The PV logger comm fail: what the controller does today, and the small change that stops it

Erbil plant, InteliNeo 5500 master, PLC sheet 10. Written from the archive and history exported on 14 October 2026.

Sheet 10 after the change

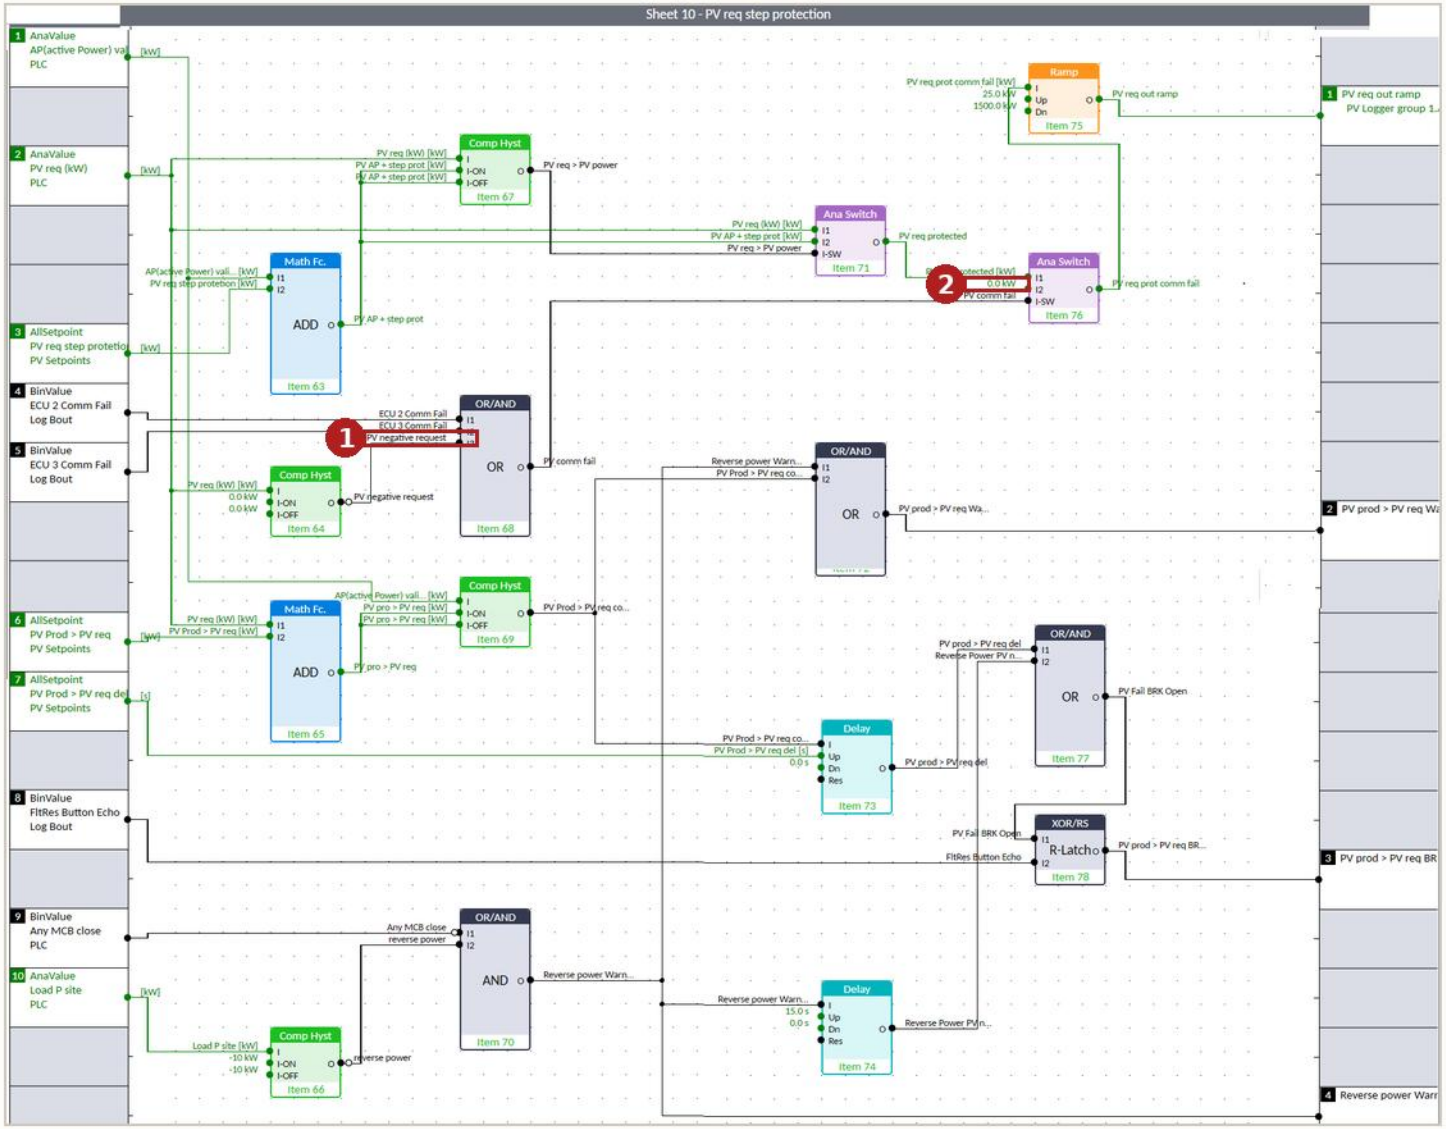
We leave the switch, we leave the ramp, we leave every protection on the sheet. We change only what sits on the switch's second input: instead of a fixed zero, it is wired to the switch's own output. Now, when a reply is missed, the switch simply repeats the last value it sent. The solar plant keeps producing what it was producing, the gensets stay where they were, and the UPS logic has nothing to react to. When the link is back the fresh request takes over, and because the plant never dropped, the request is already where it should be.

Two small things come with it. The block in front of the switch, Item 68, used to flip it also when the request was zero or below. That was a harmless guard while the second position was zero anyway; with a hold it would be wrong, because if the controller genuinely wants zero it must get zero. So that third input comes off, and Item 68 reacts only to the two comm fail signals. And there is one new block, a five minute timer on the same signal, that raises a flag we called "PV comm lost". Nothing acts on it yet. It is there so the alarm list can show that the logger has been silent for five minutes, and so that later, if the plant wants it, sheet 3 can open the PV breakers on purpose instead of leaving the inverters running blind.

1. Item 68 now reacts only to the two real signals, ECU 2 and ECU 3 comm fail. The third input is gone.

2. The same switch, now Item 77, has its own output on its second input. A missed reply makes it repeat the last value. The inverters see no drop, the gensets see no step.

3. Item 65 is new: a five minute timer on "PV comm fail". When it runs out it raises "PV comm lost", sheet output 5. For an alarm now; for sheet 3 later, if the plant agrees.

After importing the modified sheet into a copy of the archive. Everything not marked is unchanged.

Sheet 10 today

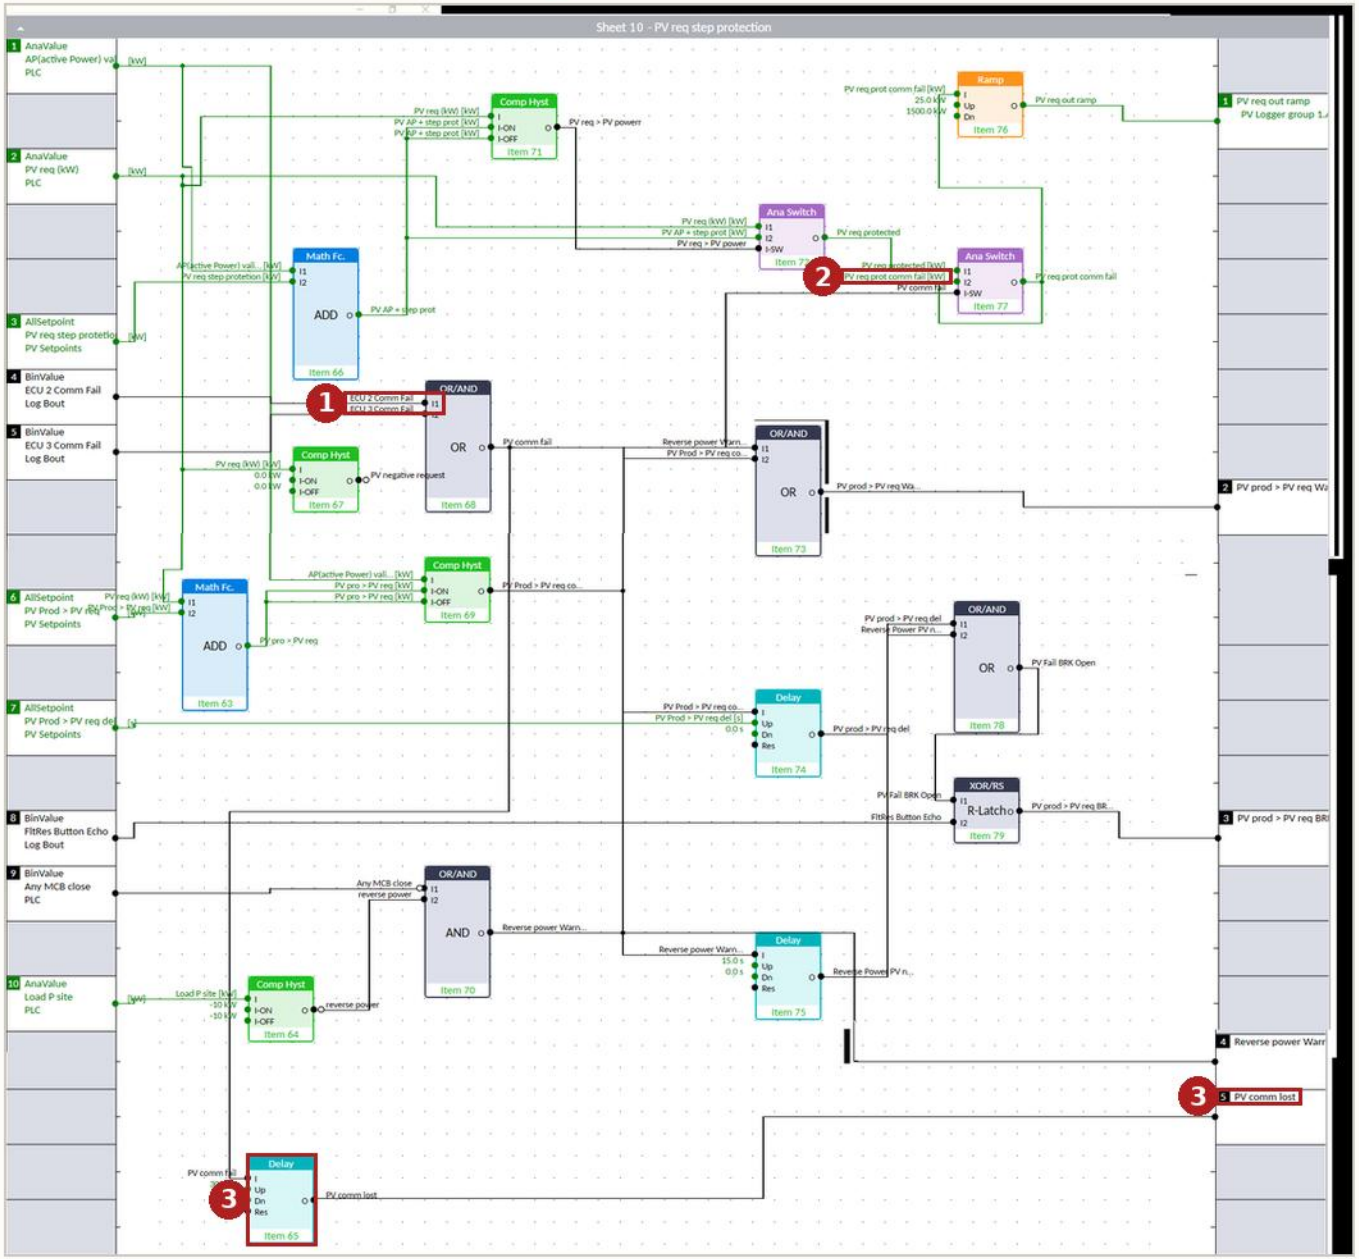
1. Item 68 decides when the request gets cut. It fires when either PV logger session misses a reply, and also when the request is zero or below.

2. Item 76 is the switch. Its second position is a fixed 0.0 kW. The moment Item 68 fires, that zero goes out to the logger, and the whole solar plant is told to stop.
